Subject: RATTLE / POP NOISE FROM INSTRUMENT PANEL AND/OR CREAK NOISE FROM A-PILLAR OVER ROUGH / BUMPY ROADS	Bulletin No: 09-043/15
	Last Issued: 11/09/2015

- This bulletin supersedes the previous bulletins 09-002/14 issued 01/08/14 and 10/03/14, 09-009/12 issued 03/09/12, 07/03/12 and 08/02/12. The SUBJECT, DESCRIPTION, REPAIR PROCEDURE and WARRANTY INFORMATION have been revised.
- Changes are noted below in Red beside the change bar.

Rattle / Pop Noise From Instrument Panel:

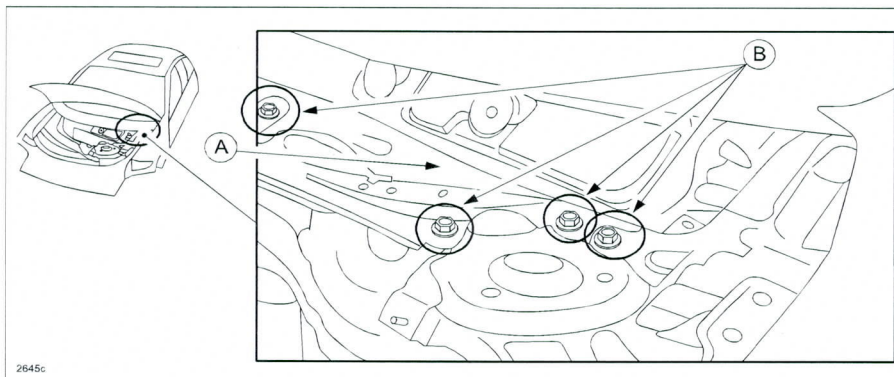
The rattle / pop noise may be caused by low cowl panel (A) mounting bolt (B) torque.

Creak Noise From A-Pillar:

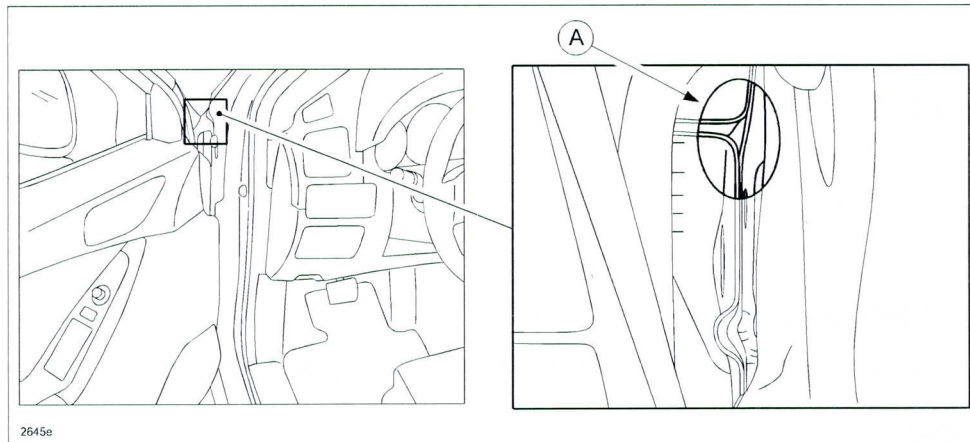
This noise may be caused by two joined panels (A) scraping together at the A-pillar. The panel weld areas have been improved during the mass-production of vehicles with VINs JM3KE*****128359 (produced June 1, 2012) or higher.

Rattle / Pop Noise From Instrument Panel:

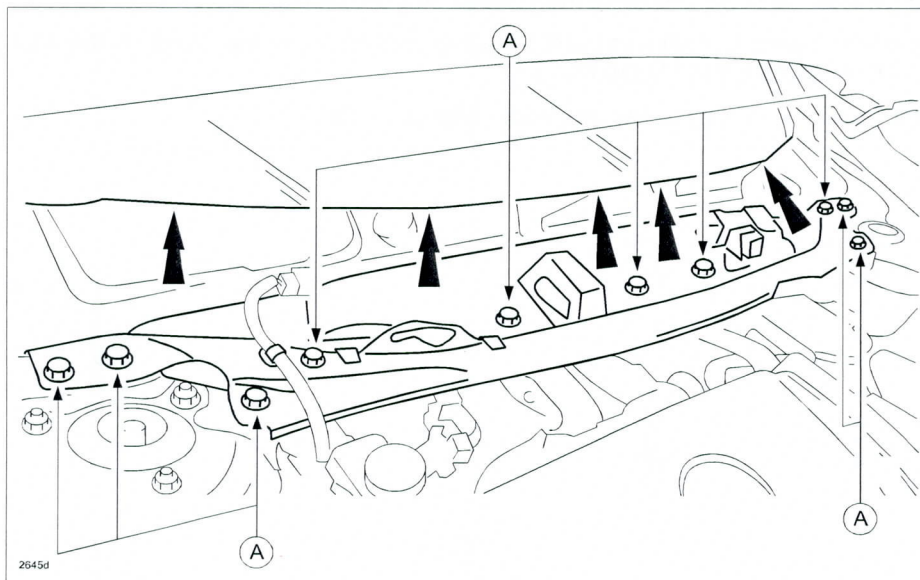
CAUTION: To avoid damaging the windshield, be sure to apply adequate protection along the bottom edge of the glass (i.e. tape or a sliced rubber hose) before retightening the cowl panel bolts.

2. Retighten all ten (10) cowl panel bolts (A) to:
Tightening Torque: 17-22 ft. lbs {22-30 Nm, 2.3-3.0 kgf-m}
3. Reinstall the cowl grille according to the online MS3 instructions or the Workshop Manual (section 09-16 COWL GRILLE REMOVAL/INSTALLATION).

Creak Noise From A-Pillar:

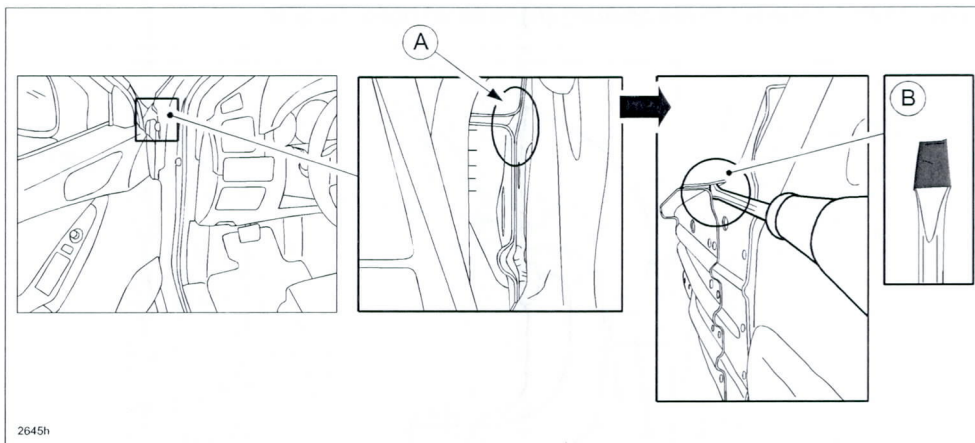
1. Identify which side the noise is coming from (repair only the problem side).
2. Remove the mud guard according to the MS3 online instructions or the Workshop Manual (section 09-16 MUD GUARD REMOVAL/INSTALLATION).
3. Remove the cowl side seal plate (A) and fender seal plate (B).

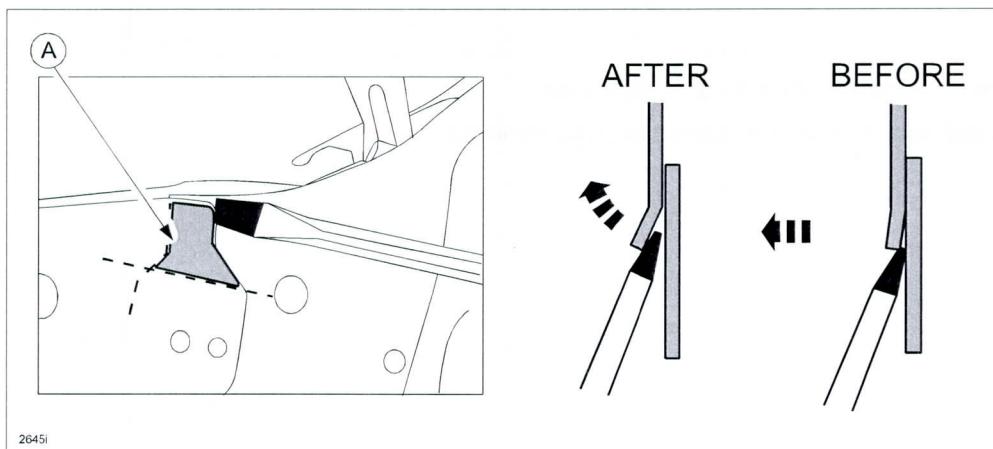
4. Open the front door and place a flat-blade screwdriver with protection tape on the tip (B) between the two panels at joint (A).

5. Bend the cowl side reinforcement panel (A) to create a clearance of more than 1 mm between the panels.

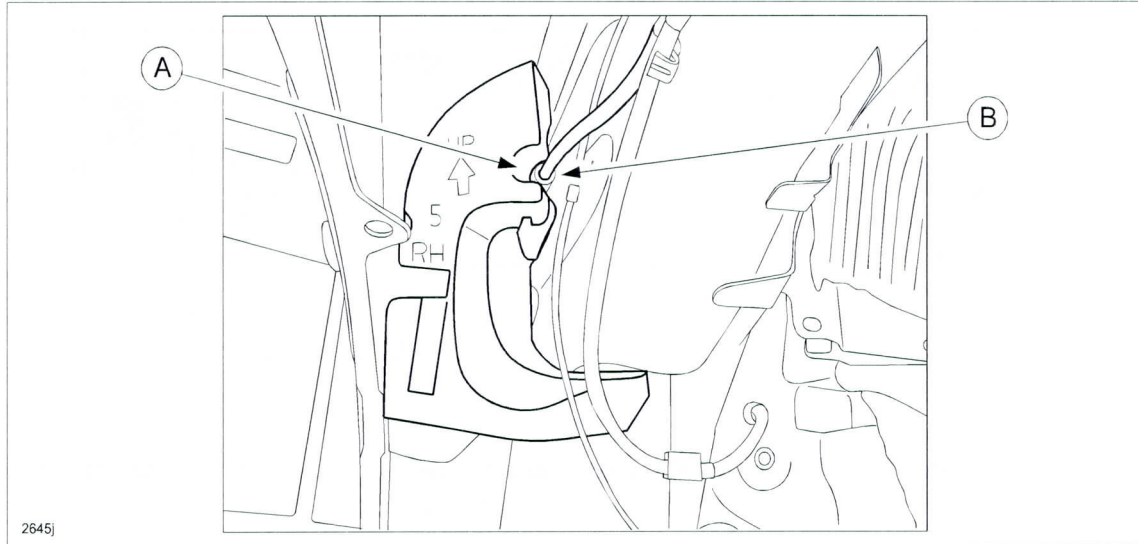
NOTE: Passenger Side Only: When reinstalling the cowl side seal plate, make sure to install the rear window washer hose (B) in the opening (A) to avoid hose damage.
